Contract #: 04-0120F4Cty: SF/ALA Rte: 80 PM: 13.2/13.9File #: 69.25B**QUALITY ASSURANCE -- NON-CONFORMANCE REPORT****Location:** Changxing Island, Shanghai, PRC**Report No:** NCR-000250**Prime Contractor:** American Bridge/Fluor Enterprises, a JV**Date:** 10-Apr-2009**Submitting Contractor:** Zhenhua Port Machinery Company, Ltd (ZPMC), Changxing Island**NCR #:** ZPMC-0224**Type of problem:**

**Reference Description:** East Shaft, Lift 2, Skin E Gusset Plate p650 welded at incorrect location**Description of Non-Conformance:**

**Subject:** NCR No. ZPMC-0224

## REQUEST FOR INFORMATION (RFI)

**Reference Description:** East Shaft, Lift 2, Skin E Gusset Plate p650 welded at incorrect location

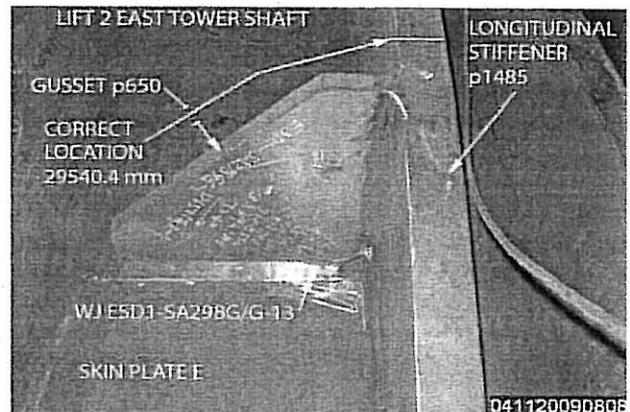
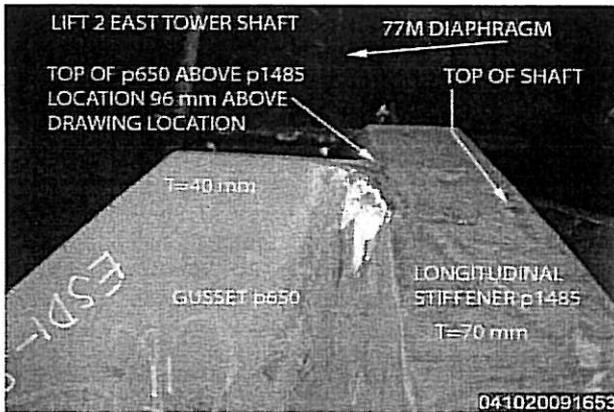
During a Final Visual Inspection per ZPMC NDT Inspection Notification Sheet 002605, QA observed that Gusset Plate p650 appeared to be in the wrong location. P650 is welded to Longitudinal Stiffener p1485 and Skin Plate E between the 77 m and 80.75 m Diaphragms in East Tower, Lift 2. The location specified in the shop drawings is 29540.4 mm from the bottom of p1485. The as-welded location is 29636 mm.

It is acceptable to leave the fabricated kink in Stiffener E2 as-built 90mm higher than per plan provided the End PL elevation is consistent with approved shop drawing. Submit the affected drawings via the FCN process

As stated in ABF-RFI-001723R00, it is acceptable to leave Kink Plate p650 at the as-built elevation.
